## meeting minutes

**Date Prepared:** November 22, 2017

**Project Name:** University of Wisconsin-La Crosse- New Student Fieldhouse & Soccer Support Facility (DFD 1512I)

**Subject:** Executive Committee Meeting

TRACK AND FIELD EVENTS

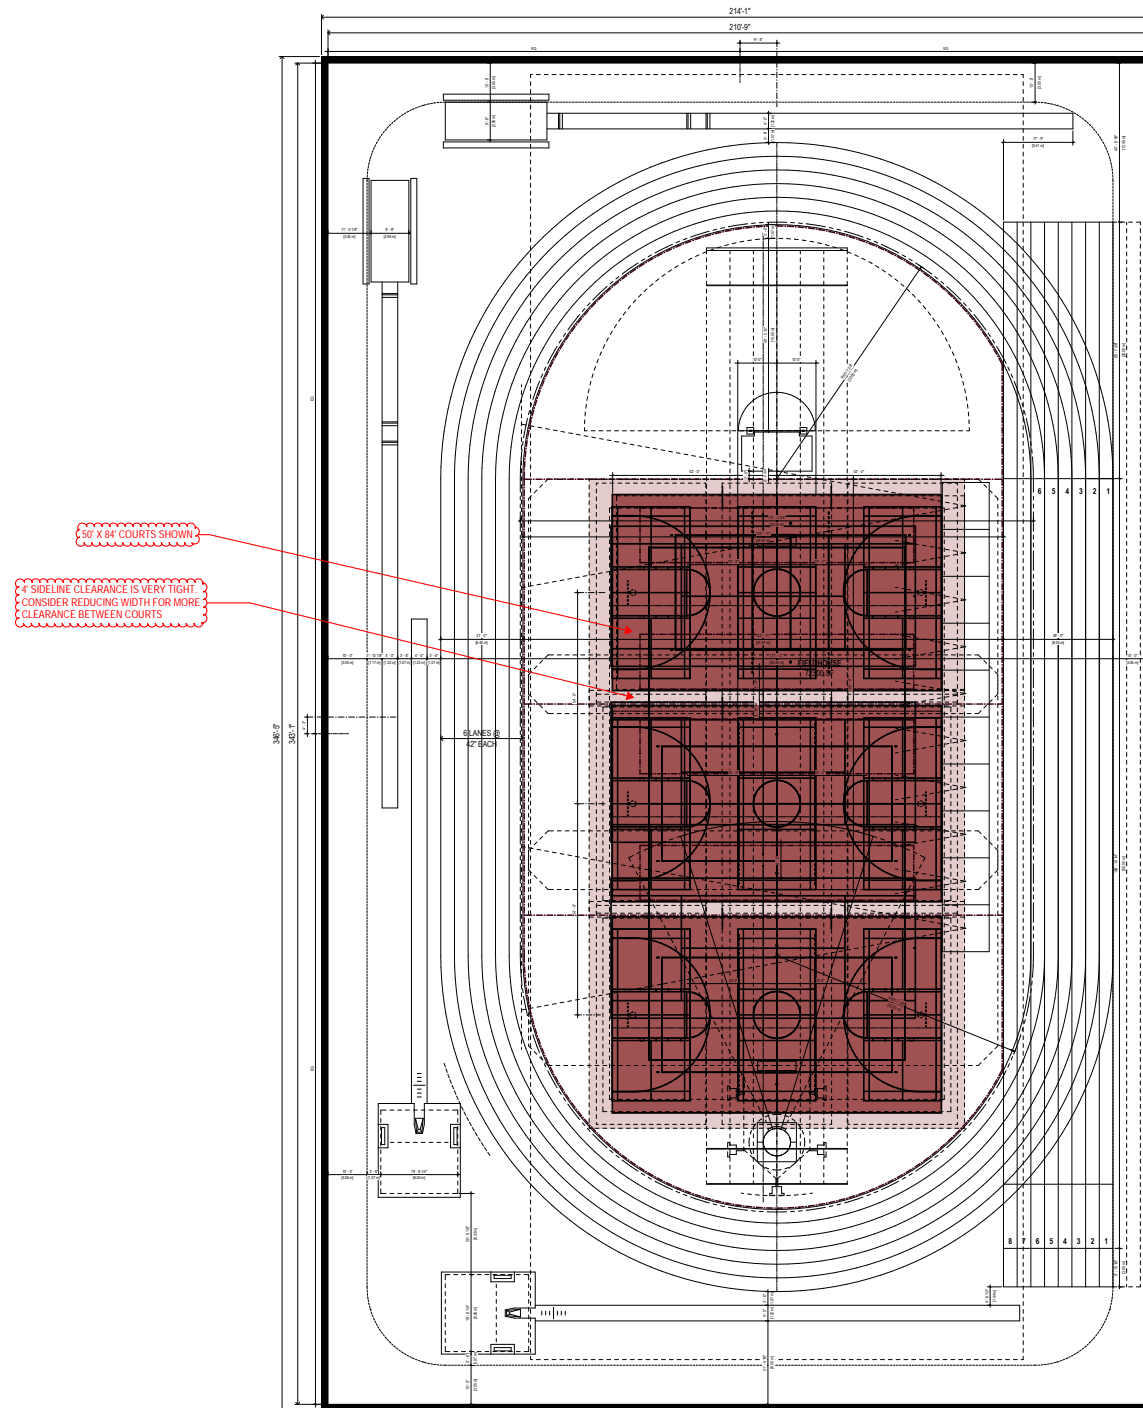
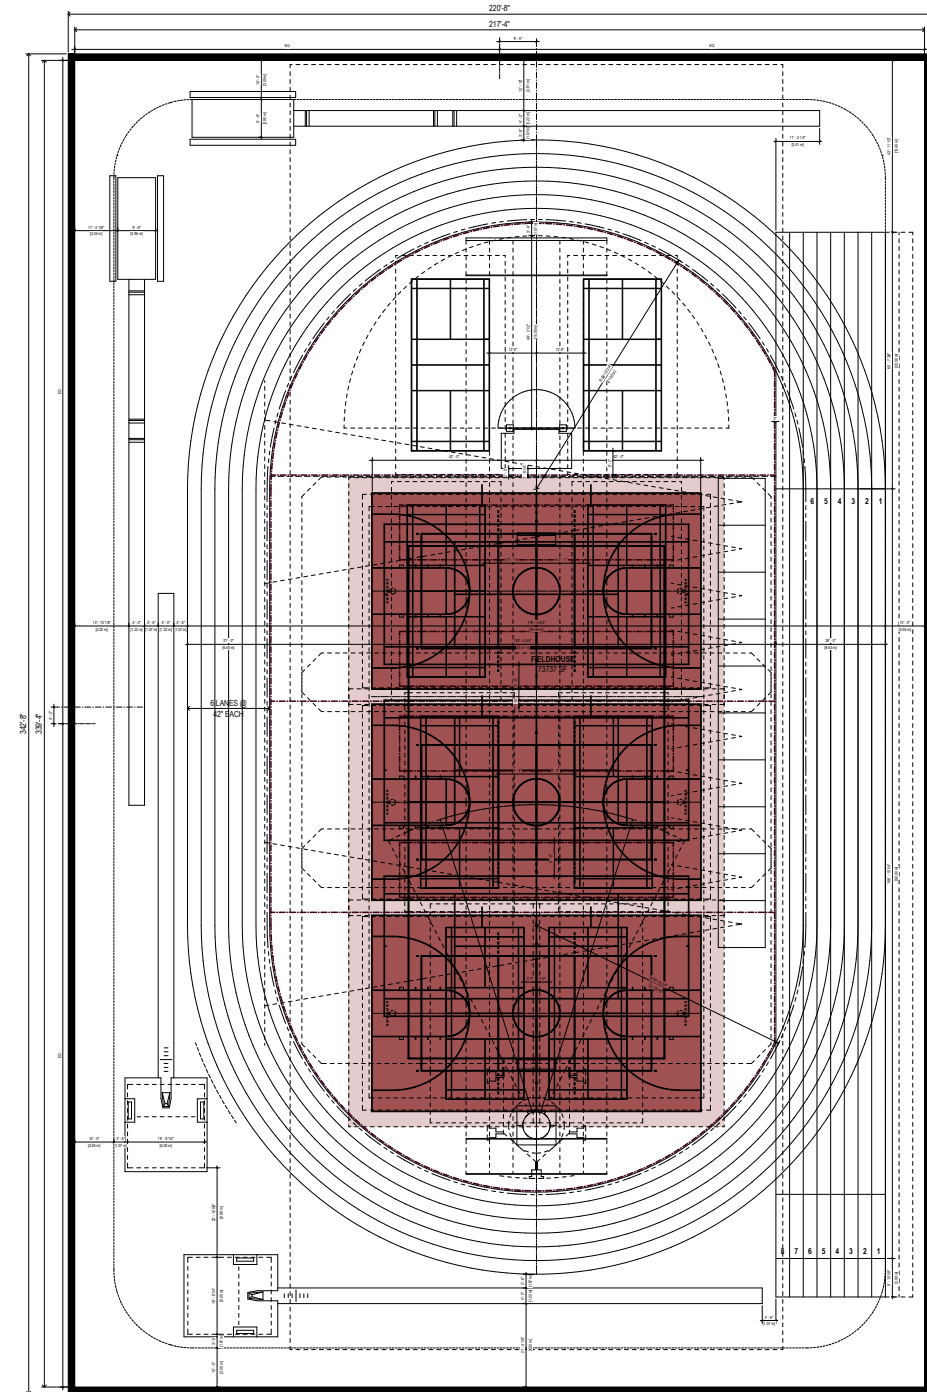
8' X 8' BY COURTS SHOWN  
 4' SIDELINE CLEARANCE IS VERY TIGHT. CONSIDER REDUCING WIDTH FOR MORE CLEARANCE BETWEEN COURTS

TENNIS

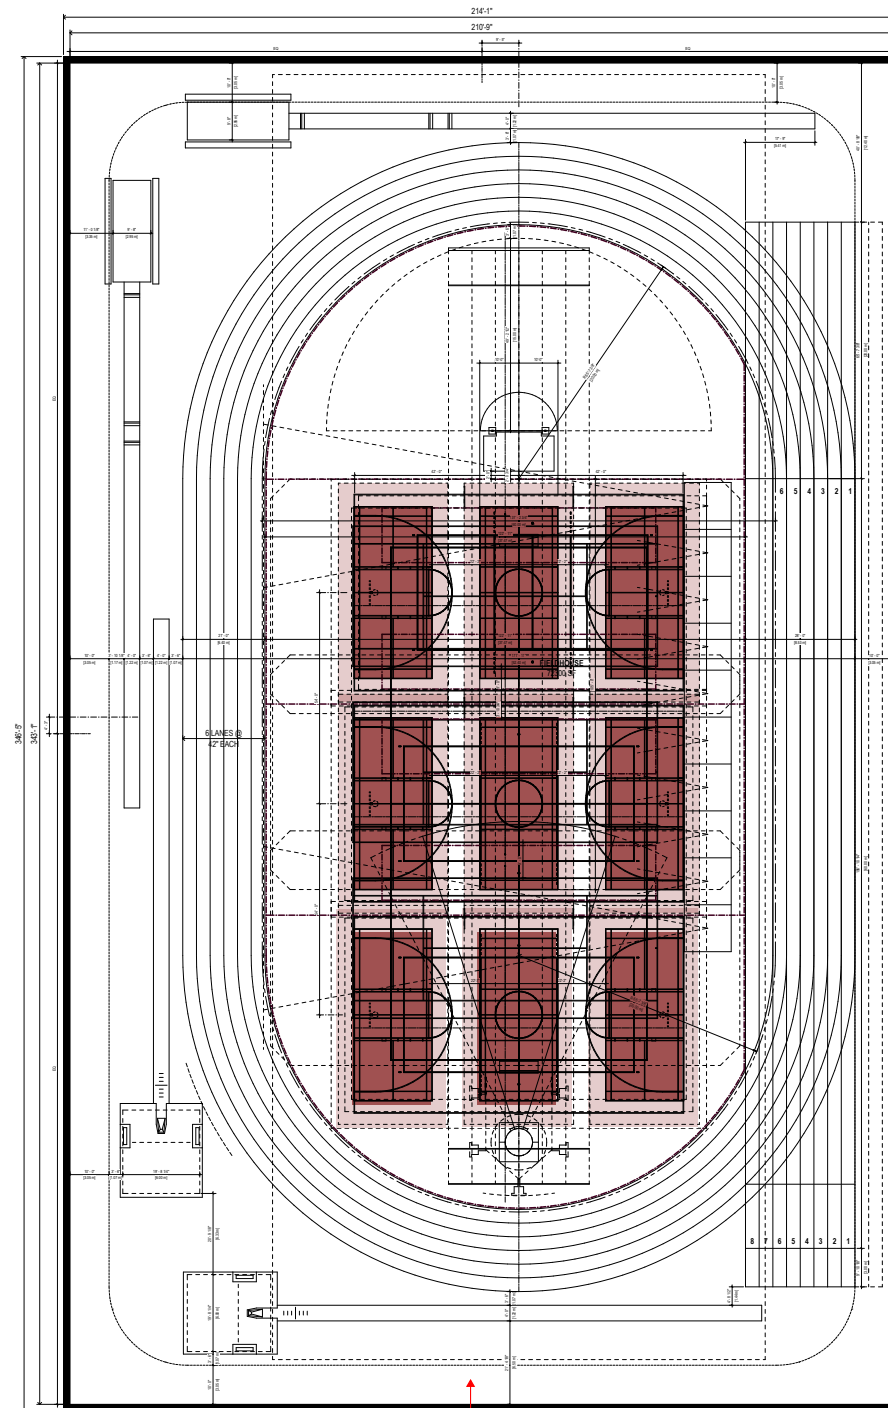
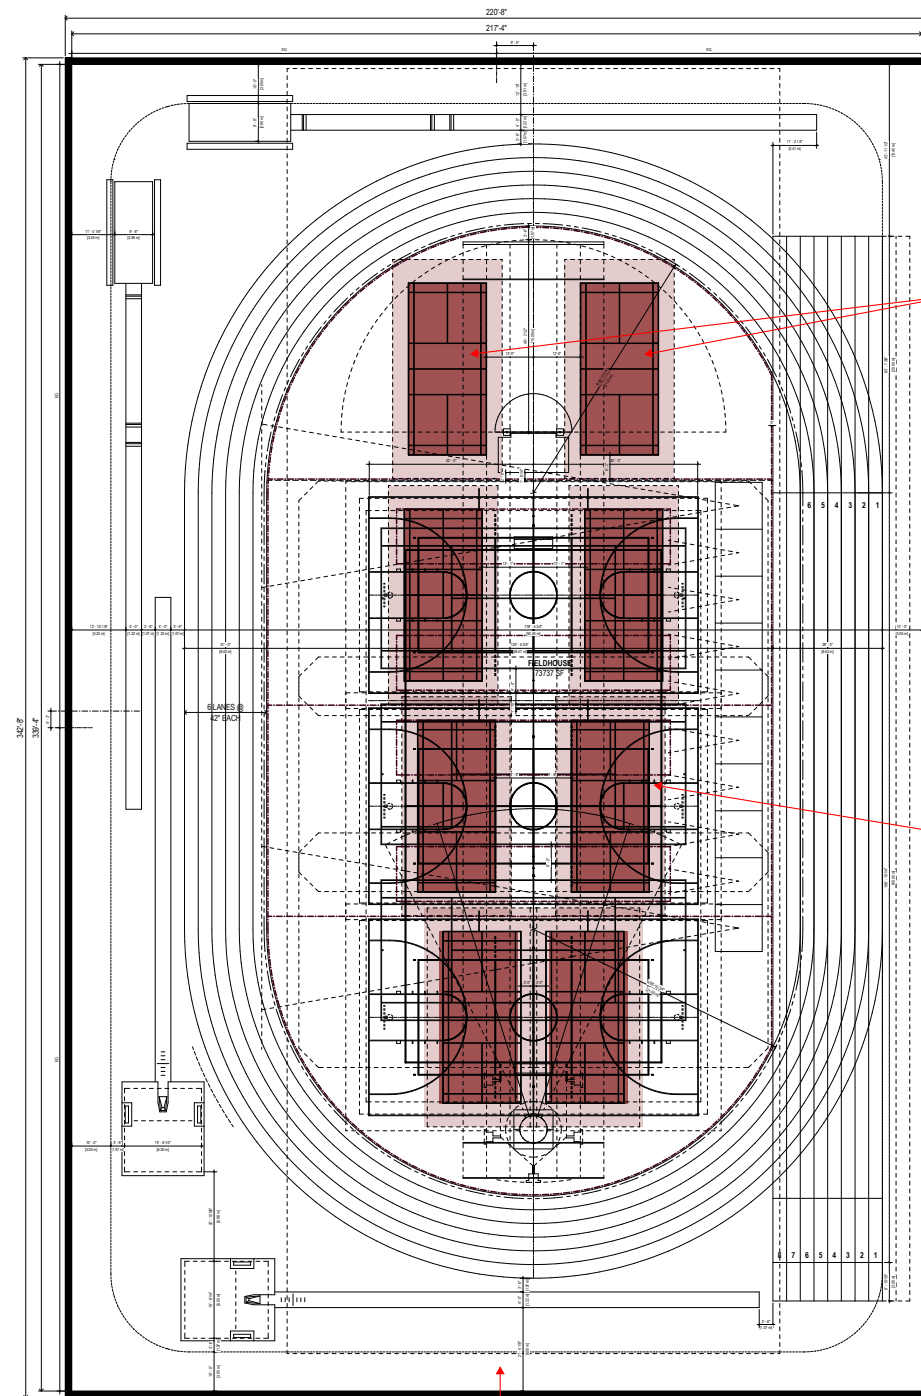
OPTIONAL COURT ORGANIZATION THAT FITS ON BOTH 20m AND 21m TRACK.

OPTIONAL COURT ORGANIZATION THAT FITS ON BOTH 20m AND 21m TRACK. THIS CONFIGURATION PREFERRED BY REC SPORTS.

COURTS ON NONSPREADABLE SURFACE IN D-ZONE OK. TWO COURTS MAX WILL FIT WITHIN D-ZONE.

BADMINTON

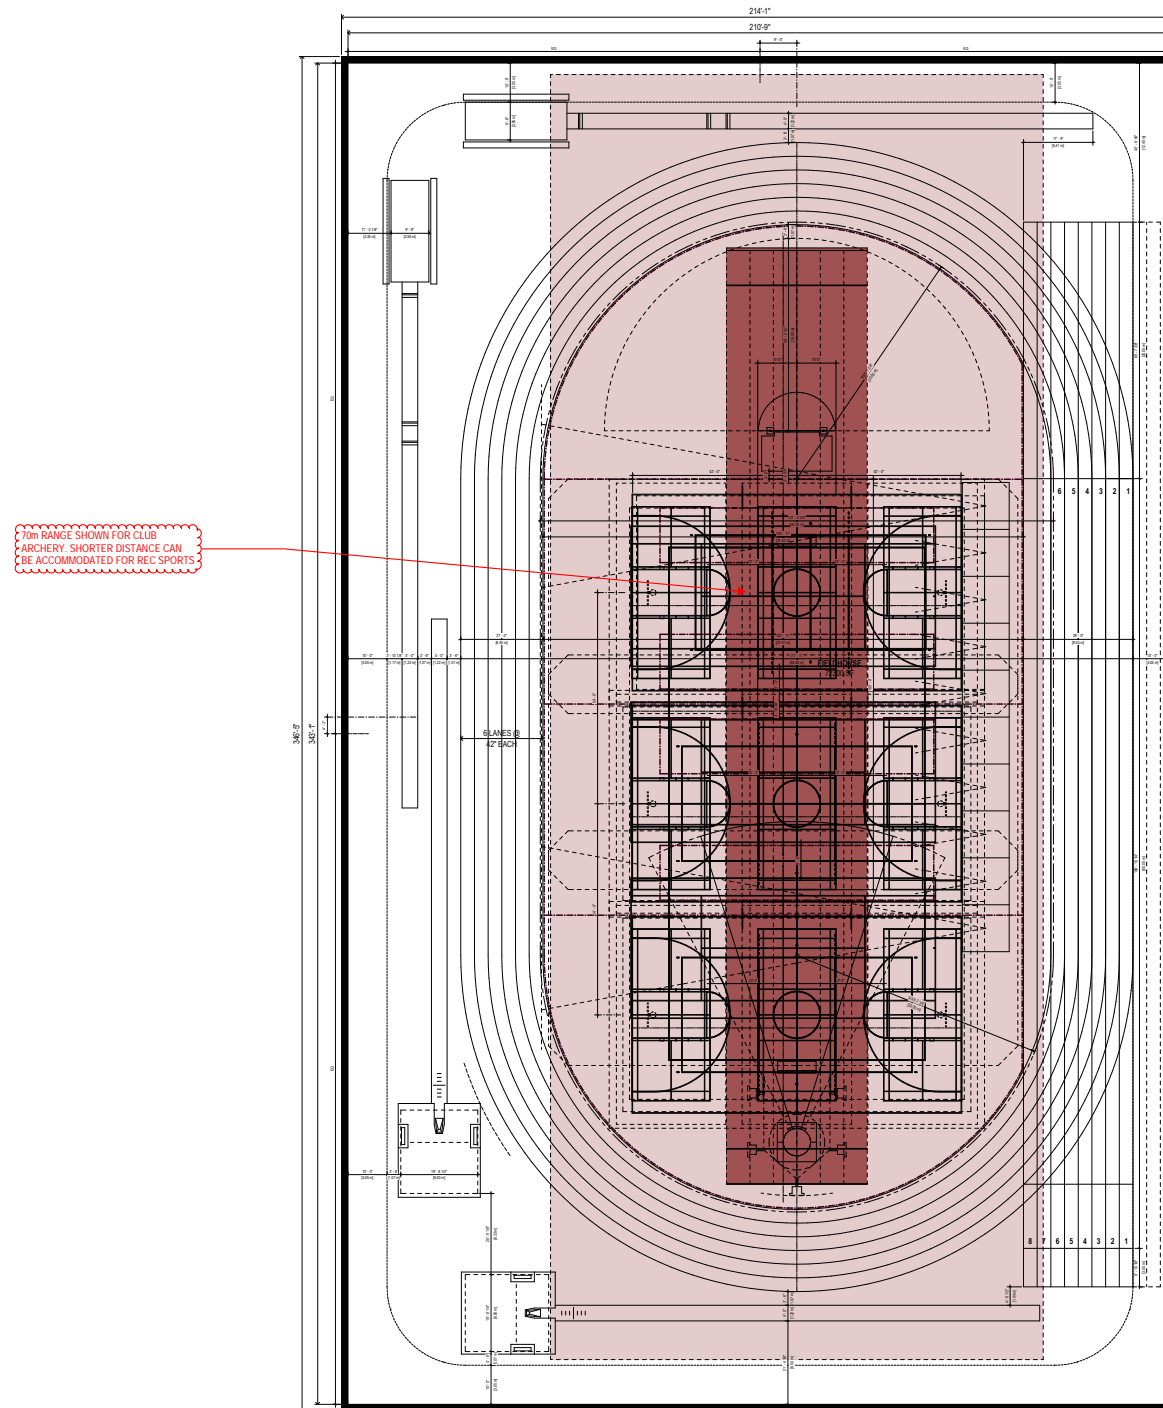
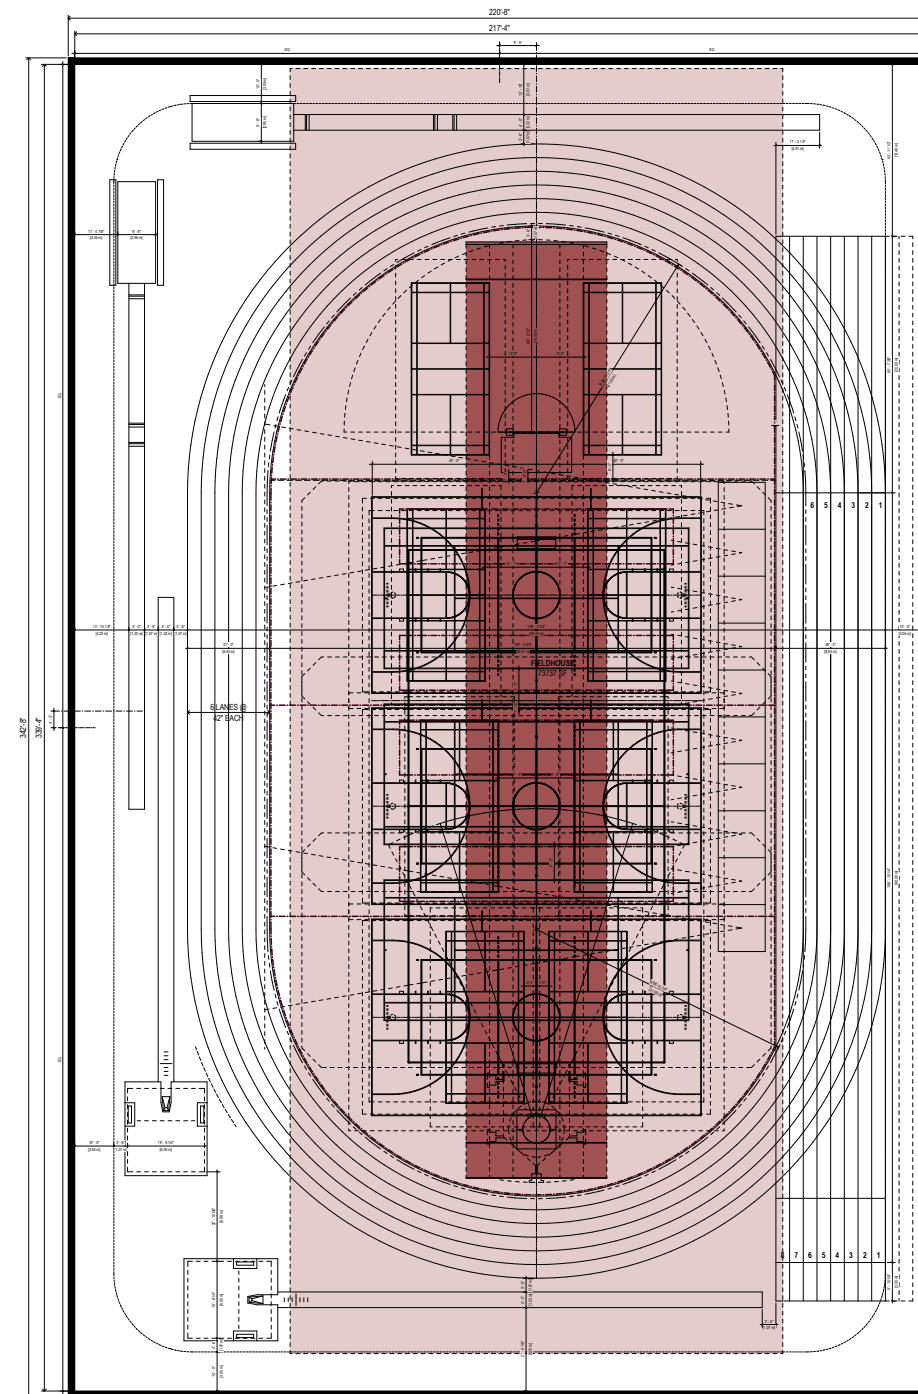
EAST-WEST LOCATION OF BADMINTON TO BE COORDINATED WITH FINAL COURT LINES OF OTHER COURTS IN OPTIONS SHOWN ON THIS DRAWING.

ARCHERY

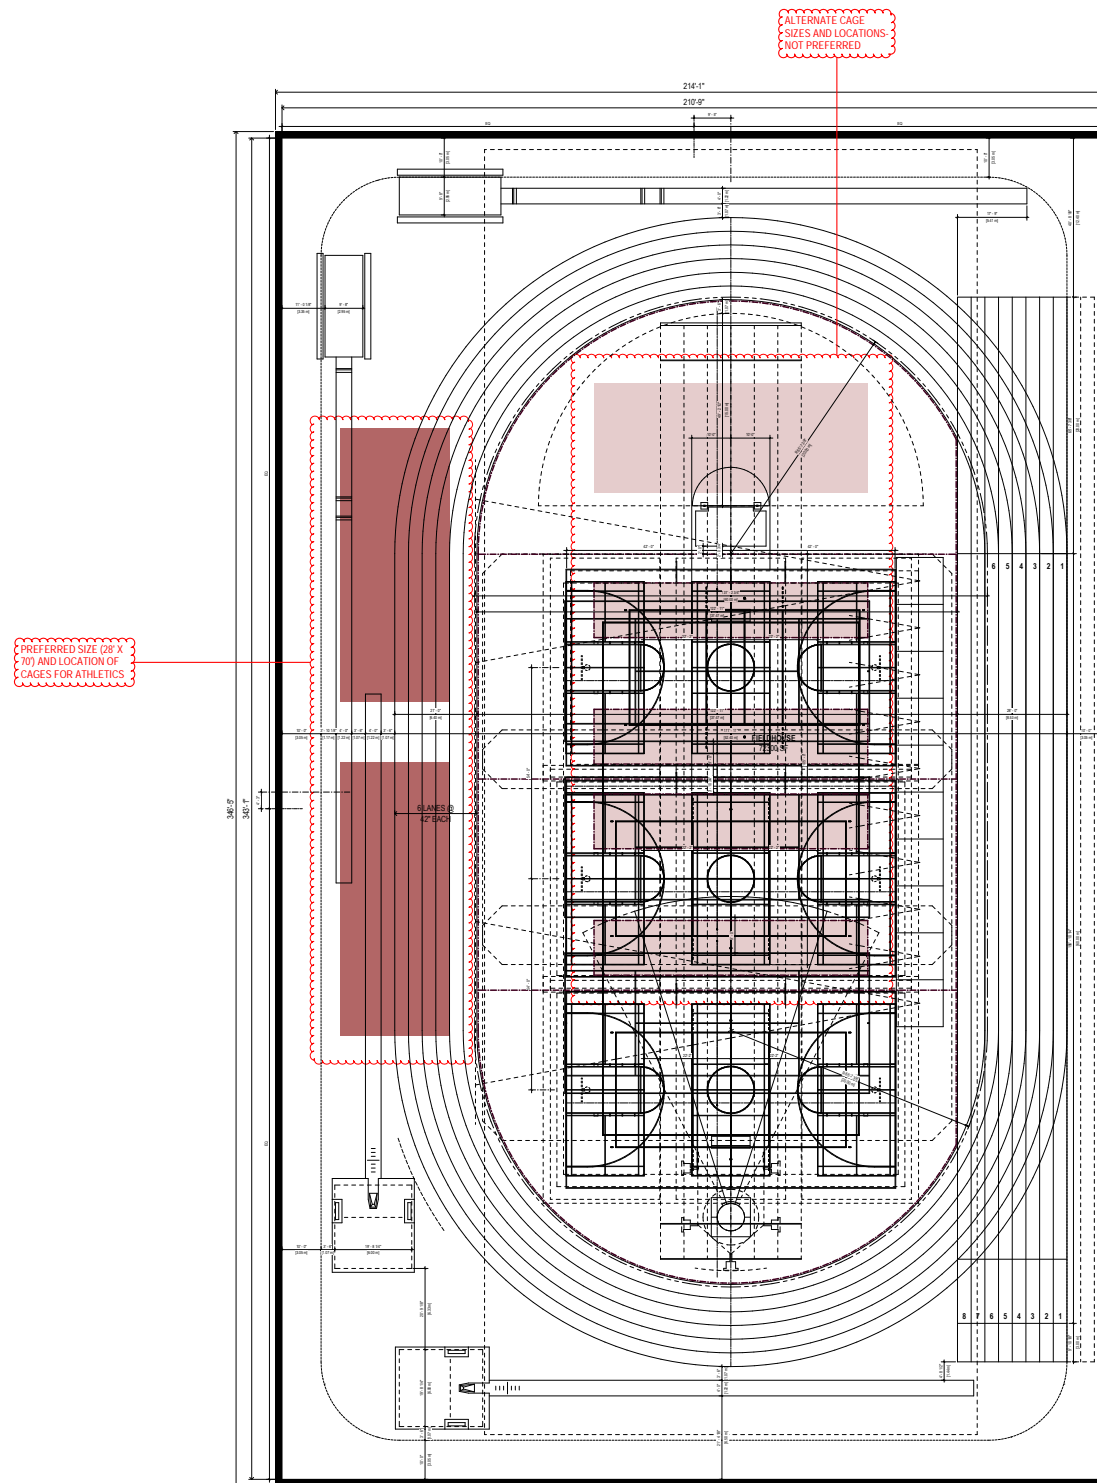
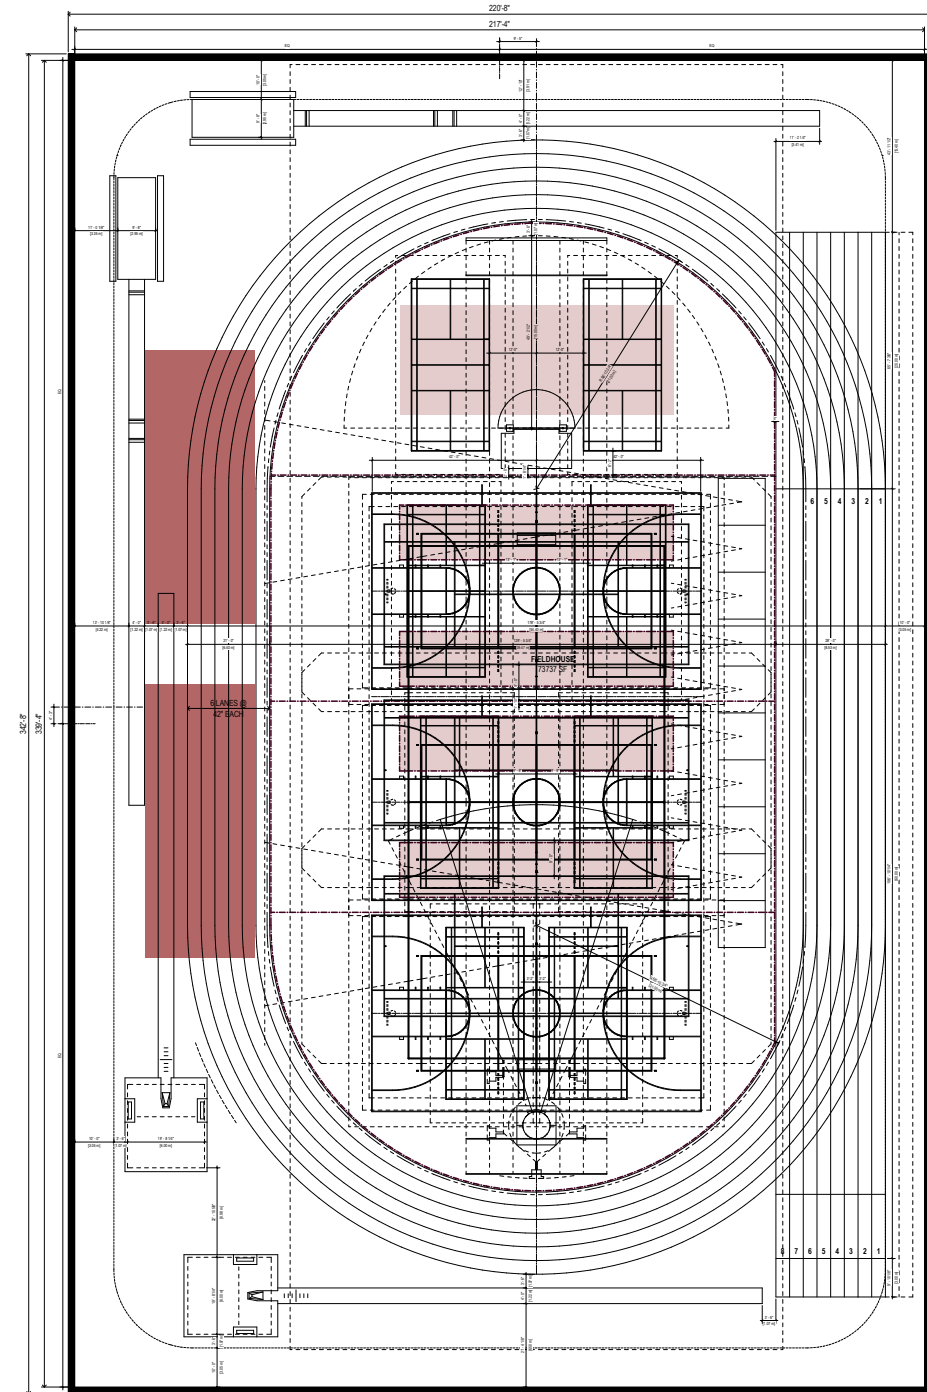
10M RANGE SHOWN FOR CLUB ARCHERY. SHORTER DISTANCE CAN BE ACCOMMODATED FOR REC SPORTS
